CITY PLANNING COMMISSION  
1231 "I" STREET, SUITE 200, SACRAMENTO, CA 95814

APPLICANT Bob Del Ponte, 6371 Riverside Blvd., Sacramento, CA. 95831  
OWNER John Bessler, 6371 Riverside Blvd., Sacramento, CA. 90401  
PLANS BY Kakavas & Associates  
FILING DATE July 30, 1990 ENVIR. DET. Negative Declaration REPORT BY DCS  
ASSESSOR'S PCL. NO. 041-0054-004, 005 and 041-0073-012

LOCATION: 3175 Lock Avenue

PROPOSAL: The applicant is requesting the necessary entitlements to subdivide 1.79± vacant acres into ten single family residential lots and two duplex lots in the Single Family Alternative (R-1A) zone.

**TENTATIVE MAP  
FOR  
THE DEL PONTE COMPANY**  
CITY OF SACRAMENTO  
CALIFORNIA

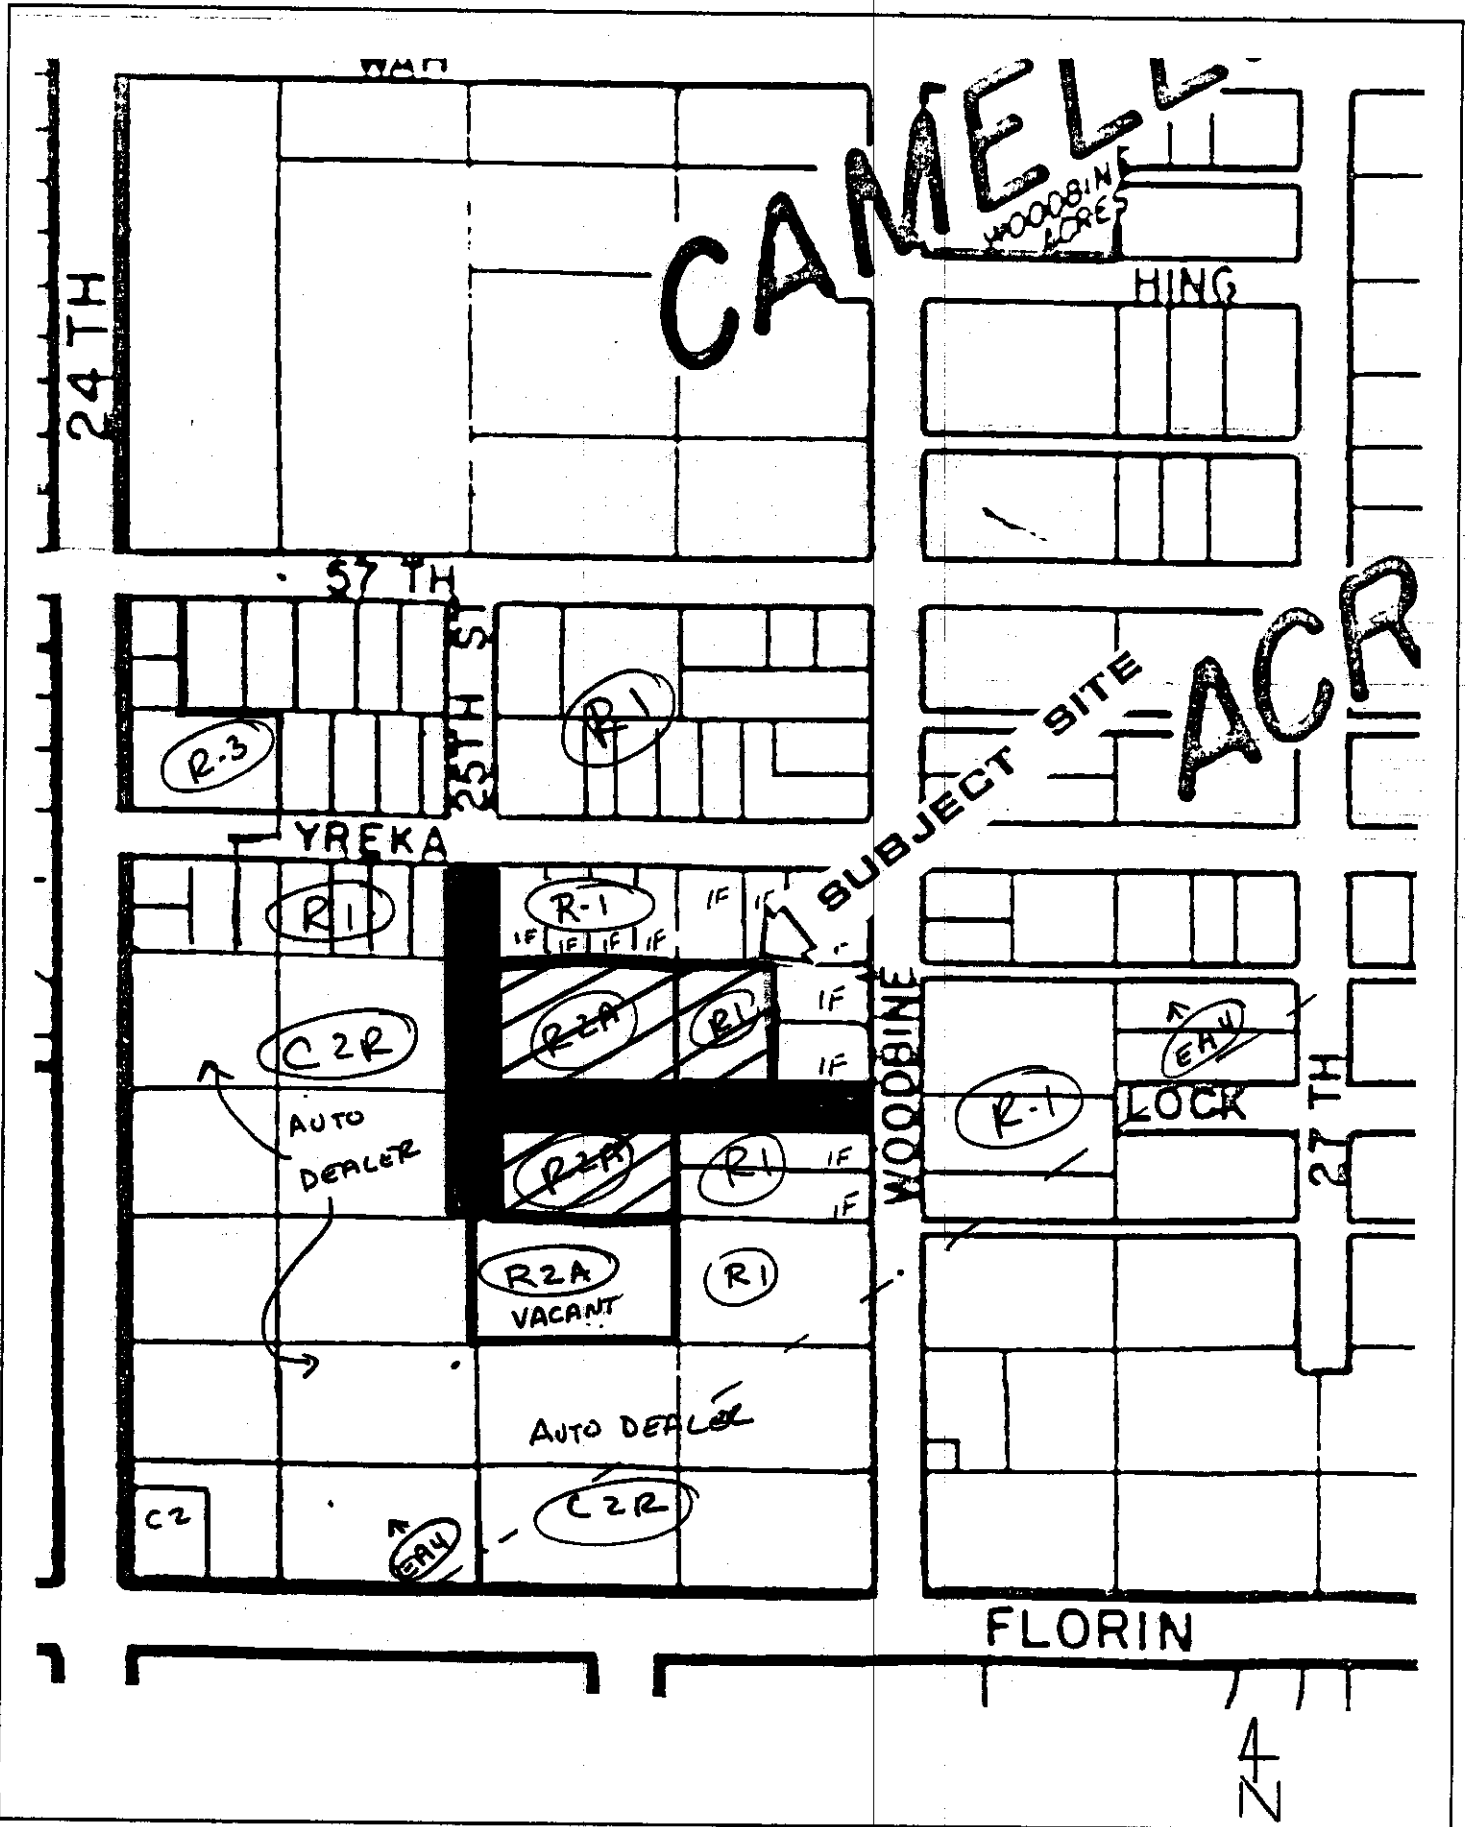
The site plans depict small rear yard areas for the duplex units. Staff recommends that the rear yard area for the duplex units be increased. It should be noted that, although driveways require a 20 foot length, the

building may be as close as 12.5 feet to the side property line (Lock Avenue). Moving the building closer to the side would help increase the rear yard area. Staff will review the rear and side yard areas and setbacks of the redesigned plans prior to the issuance of any building permits.

ELEVATIONS - EXHIBIT B

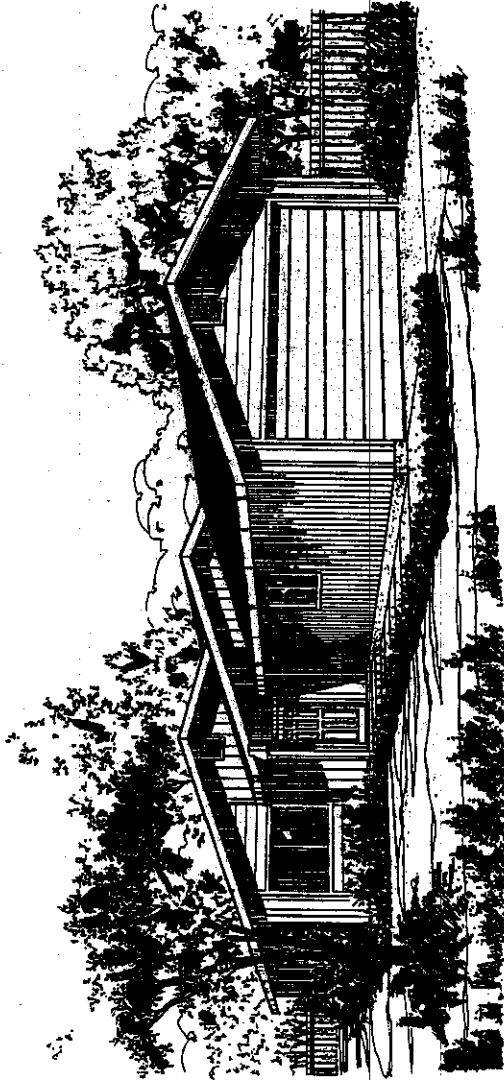
Subdivision Design and Building Materials- Single story dwellings are proposed throughout the subdivision. The Design Review Board staff has reviewed the proposed dwellings and has provided the following recommendations.

- At a minimum, use lap siding on the front elevations and 2' 0" wrap each side;

- Metal sectional garage doors are required with raised panel design;
- Dwellings shall be roofed with a minimum twenty five year laminated dimensional composition shingle with color complementing exterior paint colors (roof pitch 5 in 12 minimum);

- Exterior paint colors shall be coordinated with roof color;
- Front doors to be metal with six inch raised panels minimum;
- Vents on front elevations should be trimmed and possibly boxed out flush with overhang feature;

- Windows at front elevation should be gridded. In addition, front window should be enhanced using: a) bay window; b) pop window straight out 1' 0"; c) keep flush but flank with shutters. Each variation should be used several times in this subdivision.

- Center a window in garage side wall to avoid long uninteresting wall area. Grid to match front windows;
- Roof lines should be varied such as: clipped gable on garage, dutch gable on garage, etc.;

- Heating and air conditioning equipment should be in attic not on roof top;
- Fence rear yard areas from front yard setback with 6' 0" wood fence;
- Landscape front yards with sod and install sprinkler systems for each home; and,
